Access Compliance Report Public Rights-of-Way (Curb Ramps)

Intersection ID: 10030508 Main Street: LITTLE_GEM_LN **Cross Street: N/A** Location: SW **Overall Compliance: No Severity Score:** ADA ID: D2BECDDDC694 Ramp Type: Perp Initial Pass/Fail: Pass

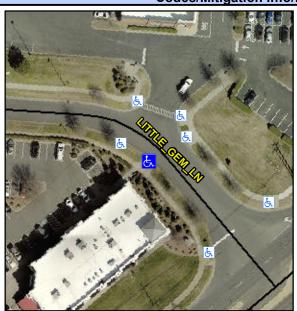
LITTLE GEM LN Street 1 Name Stop Condition-Street 2 None Street 2 Name N/A Stop Condition-Street 1 N/A Possible Solutions: Remove & Replace Entire Ramp. Surveyor Notes: N/A PROW/ADA: Not Found, R304.5.3, R305.2

Field Measurements/Component Compliance						
Compliance Description Data		Comp	liance	Description	Data	
N/A	Ramp Length (in)	97.5	Yes	Ramp	Slope (%)	5.4
Yes	Ramp Width (in)	72.0	Yes	Ramp XSlope (%)		1.3
N/A	Flare Type LT	Sloped	N/A	Flare Type RT		N/A
N/A	Flare Slope LT (%)	7.3	N/A	Flare Slope RT (%)		3.7
N/A	Flare Traversable LT?	No	N/A	Flare	Traversable RT?	No
Yes	Landing Length (in)	74.5	Yes	DWS	Provided?	Yes
Yes	Landing Width (in)	72.0	Yes	DWS	Contrast?	Yes
Yes	Landing Slope (%)	1.4	Yes	DWS	Length (in)	24.5
No	Landing X Slope (%)	3.7	Yes	DWS	Full Width?	Yes
N/A	Landing Curb? (Y/N)	No	No	DWS	Offset (in)	4.5
N/A	Shared Landing?	No				
Yes	Gutter Ponding?	No	Yes	Gutte	r Slope (%)	1.2
Yes	Gutter Lip Ht (in)	0.0	Yes	Gutte	r X Slope (%)	1.6
N/A	Painted X Walk1?	No	N/A	Paint	ed X Walk2?	N/A
	X Walk 1 Direction	To NE		X Wa	lk 2 Direction	N/A
N/A	X Walk 1 Width (in)	N/A	N/A	X Wa	lk 2 Width (in)	N/A
	X Walk 1 Slope (%)	1.0		X Wa	lk 2 Slope (%)	N/A

X Walk 1 X Slope (%)	1.5		X Wa	lk 2 X Slope (%)	N/A
N/A	Ramp inside XWalk1?	N/A	N/A	Ram	inside XWalk2?	N/A
	Road Slope (%)	N/A	N/A	Clear	Space?	Yes
	Road X Slope (%)	N/A	N/A	Clear	Space to XWalk (in)	N/A
Yes	Any Obstructions?	No	Yes	Storn	n Grate/Utility Hazard?	No
	Obstruction Type			Storn	n Grate/Utility Type	
		N/A				N/A
			Yes	Surfa	ce Condition? (G/P)	Good
Whiteen
